CITY OF ALBUQUERQUE

RE: 9821 Buckeye St. NW
Revised Grading and Drainage Plan
Engineer's Stamp Date: 01/28/21
Engineer's Certification Date: 03/28/22
Hydrology File: B13D011D

DRAINAGE AND TRANSPORTATION INFORMATION SHEET (REV 6/2018)

ENGINEER'S SEAL DAVID SOULE NEW MEXICO REGISTERED PROFESSIONAL ENGINEER 1/28/21 DAVID SOULE P.E. #14522	LOT 19 BLK 2 U 2 KPH 9821 BUCKEYE ST. NW	DRAWN BY DEM
	GRADING AND DRAINAGE PLAN	DATE 1-26-21
	 RIO GRANDE Engineering P.O. BOX 53924 ALBUQUERQUE, NM 87199 (505) 321-9099	SHEET # C1 JOB #

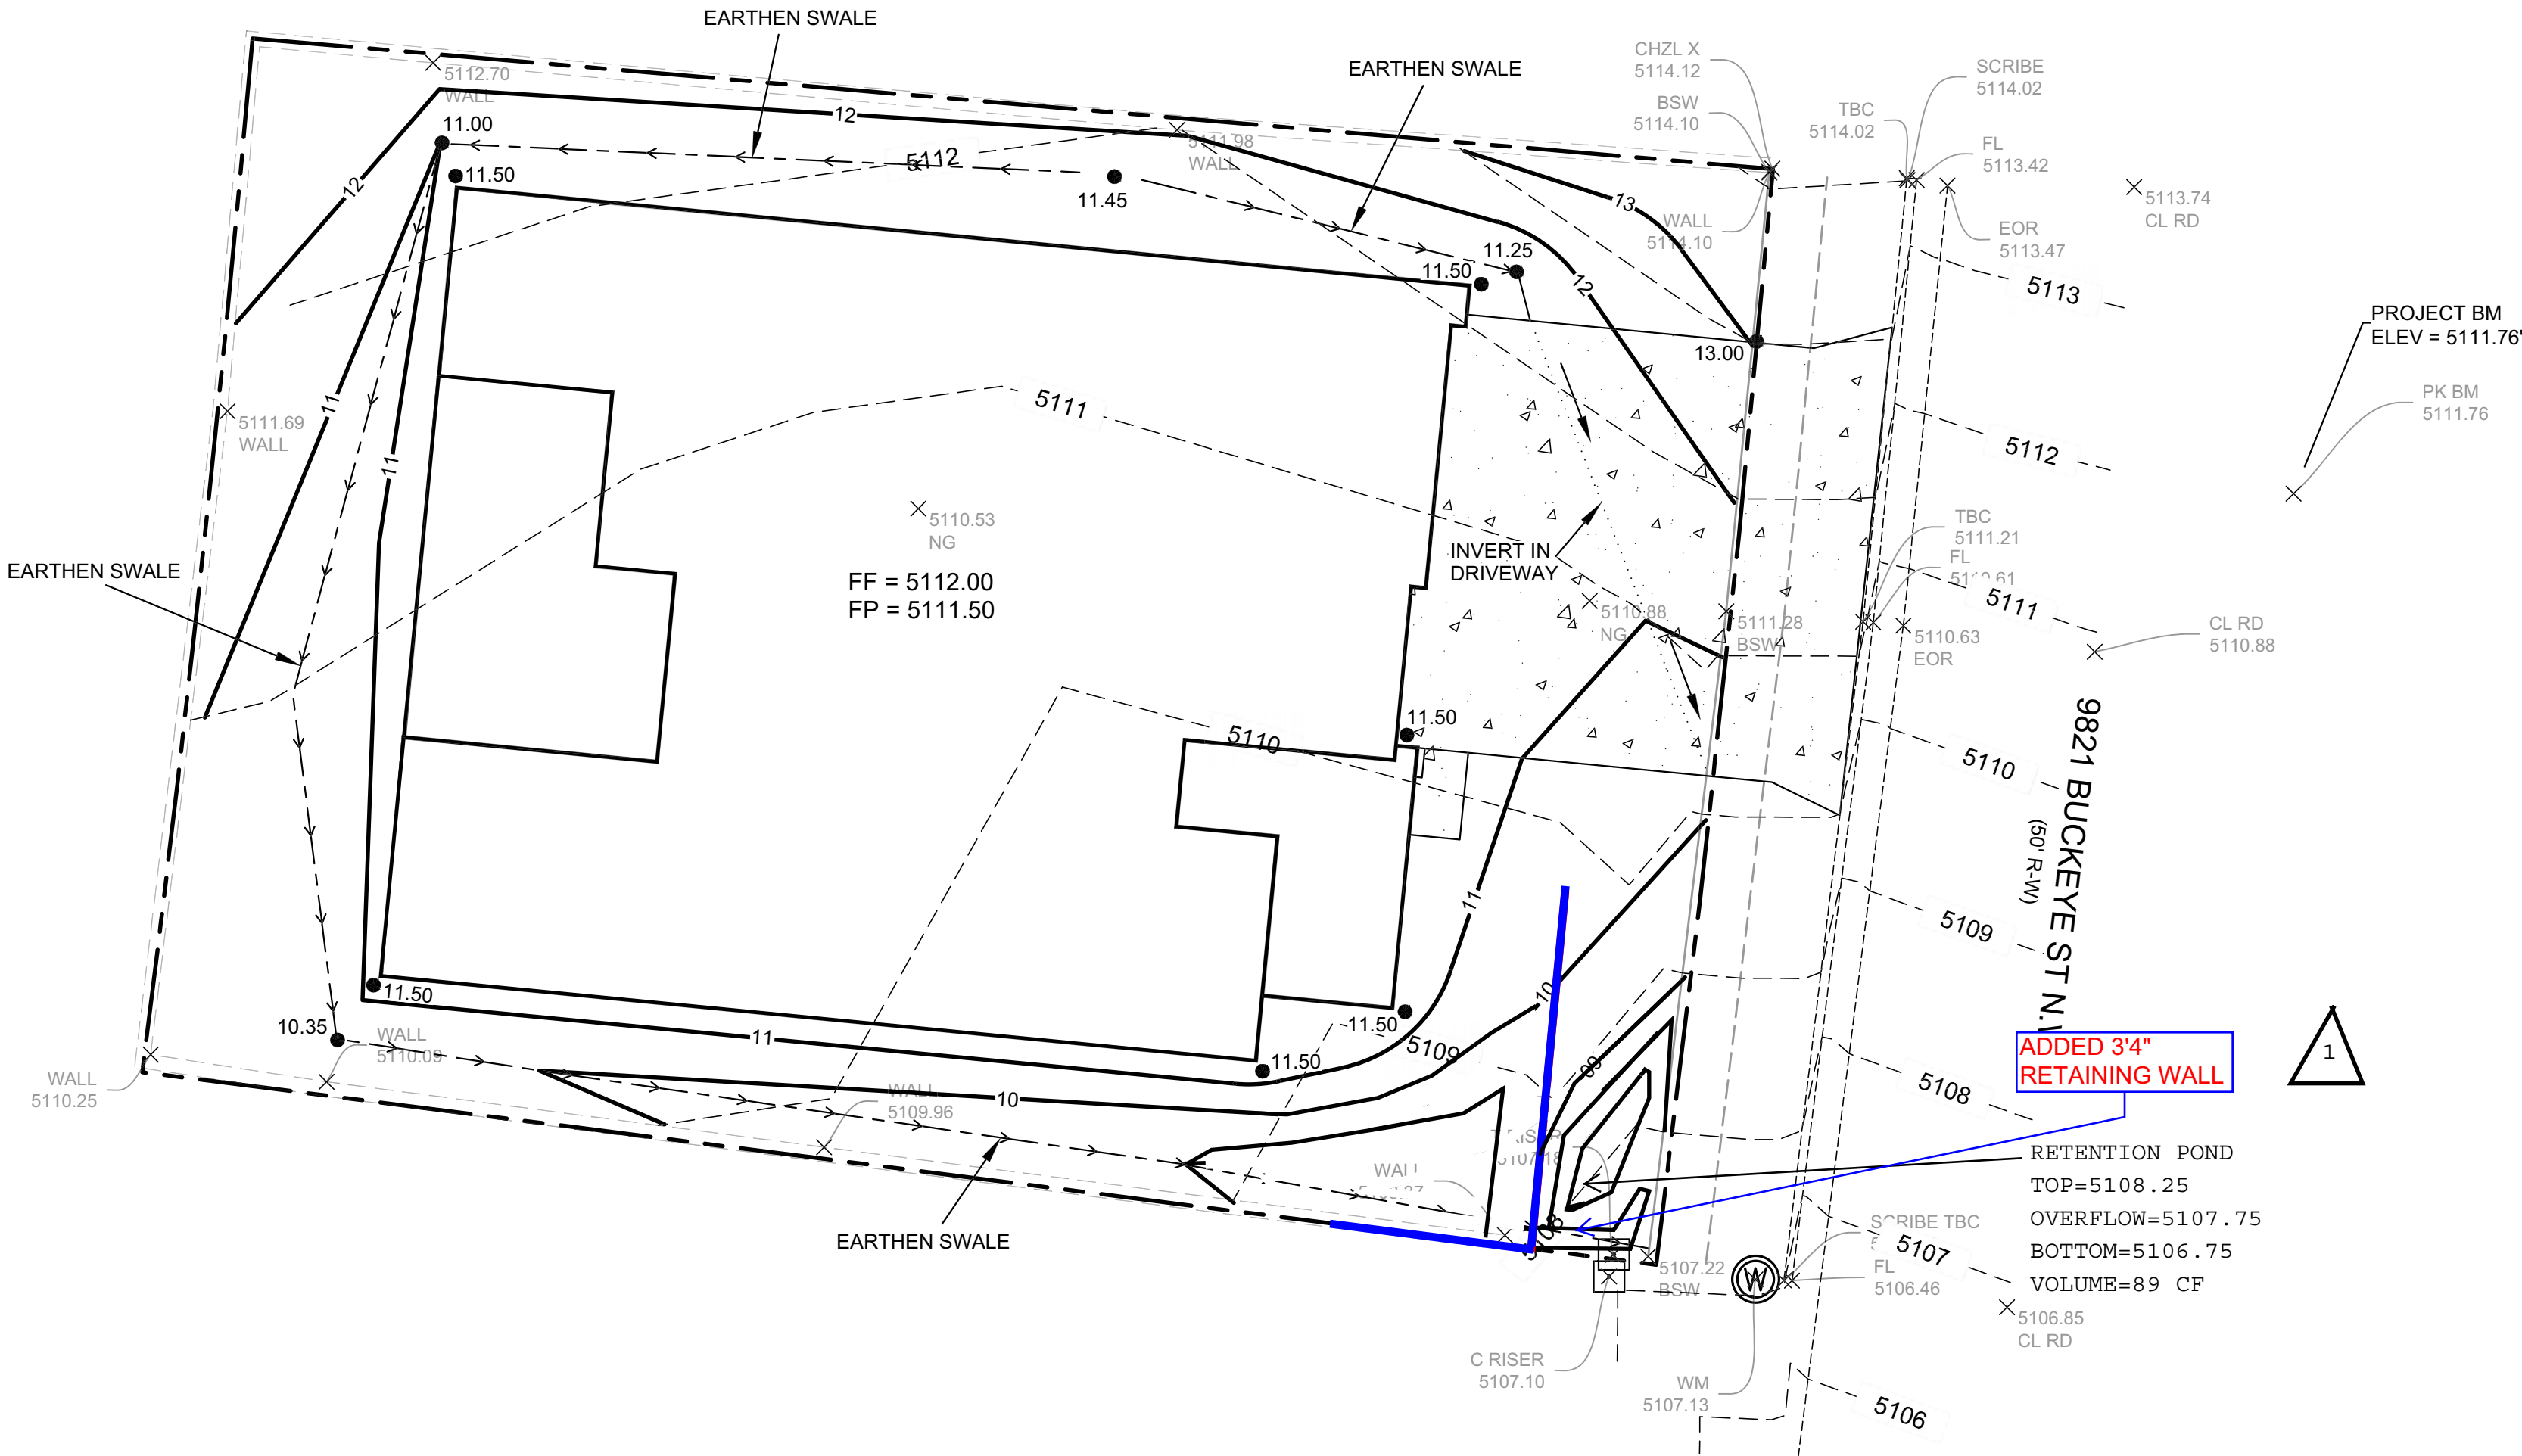
REVISED DUE TO RETAINING WALL ADDED IN FRONT, SUBMITTAL AT COA REQUEST

ADDED 3'4" WALL AT SOUTHEAST CORNER
3/28/22
